SANTA CLARA VALLEY WATER DISTRICT

TO: Board of Directors**FROM:** Nina Hawk**SUBJECT:** Comments on Draft Environmental Impact Report for Proposed Long-Term Operations of the State Water Project**DATE:** 1/10/2020

Re: Long-Term Operations (LTO) of the State Water Project (SWP) Project

Figure 1. Dr. Wim Kimmerer, Delta Environmental Flows Group Presentation, SWRCB Flow Policy, Workshop 1. ⁸

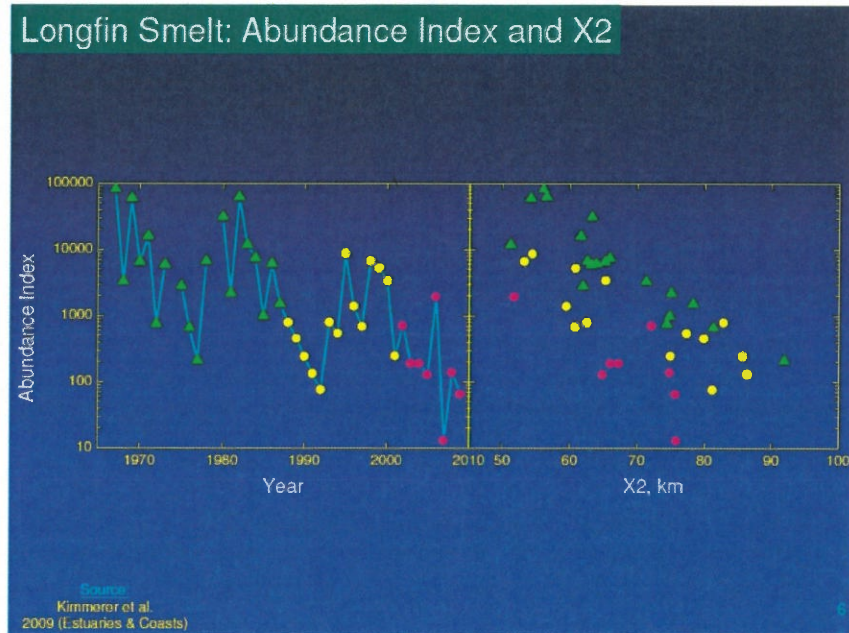
(Kimmerer 2004, p. 90.)⁶ The fact that the modeled relationship has changed over time, such that there are fewer and fewer longfin smelt predicted for the same level of outflow, See e.g., Tamburello et al. 2019⁷, supports Dr. Kimmerer's caution in interpreting the relationship. The change in the longfin smelt: X2 relationship was illustrated by the State Water Resources Control Board's expert panel during its Flow Policy workshops in 2010. See Figure 1, which shows how the longfin Smelt relationship has changed over-time, indicating less species abundance for the same quantity of outflow. As the figure illustrates, species abundance in the survey area (which

does not represent the species full range) has continued to decline (compare green points to purple points) for the same outflow. Based on this relationship, providing more outflow would not provide significant species benefits, rather determining the reason for the decadal shift downward would be more informative of future management actions. Spring Delta outflow does not appear to be the direct mechanism explaining this relationship.

Figure 2, Longfin Smelt Symposium, Dr. Fred Feyrer.

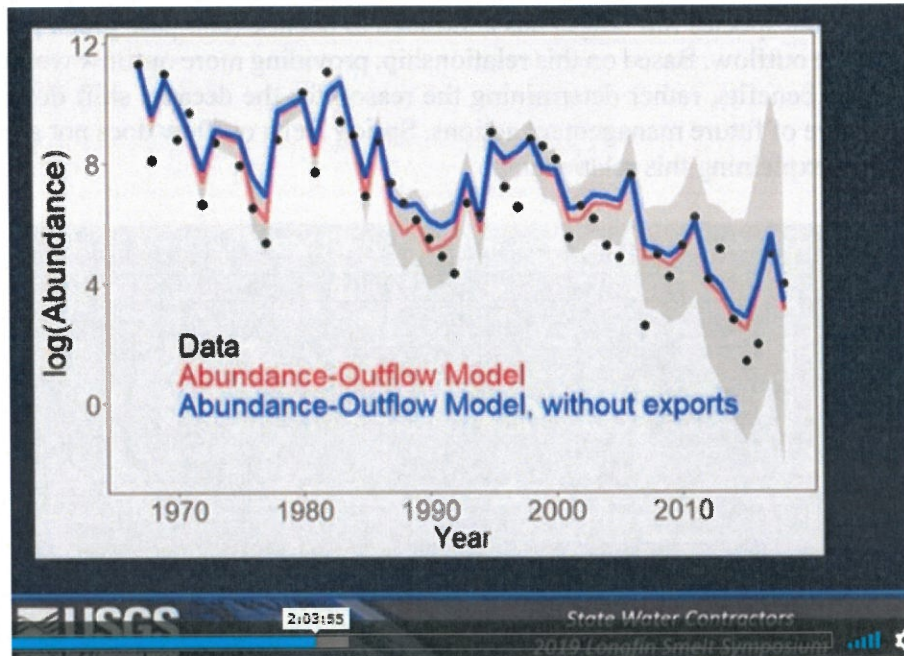
To further illustrate the limited predictive ability of the model, Dr. Feyrer showed a preliminary draft analysis at the recent Longfin Smelt Symposium comparing the predicted change in abundance if all water diversions in the system were eliminated, not just the SWP. While this analysis still needs further review, it indicates that there may only be a small predicted increase in abundance if all diversions are eliminated. See Longfin Smelt Symposium, at 2:03:55, Figure 2. It is therefore not surprising that the substantially smaller change in outflow related to the Proposed Project would not result in a significant change in species abundance.

Dr. Feyrer's prediction is consistent with the relative flatness of the relationship between winter-spring X2 and species abundance. As another way to view the relationship, the Delta Science Program's Delta Outflow Panel Report recommended that the longfin smelt relationship also be considered on a linear scale, thereby removing the log-scale from the original relationship. The result is a fairly flat relationship, particularly within the range of flows at issue for the Proposed Project Figure 3.
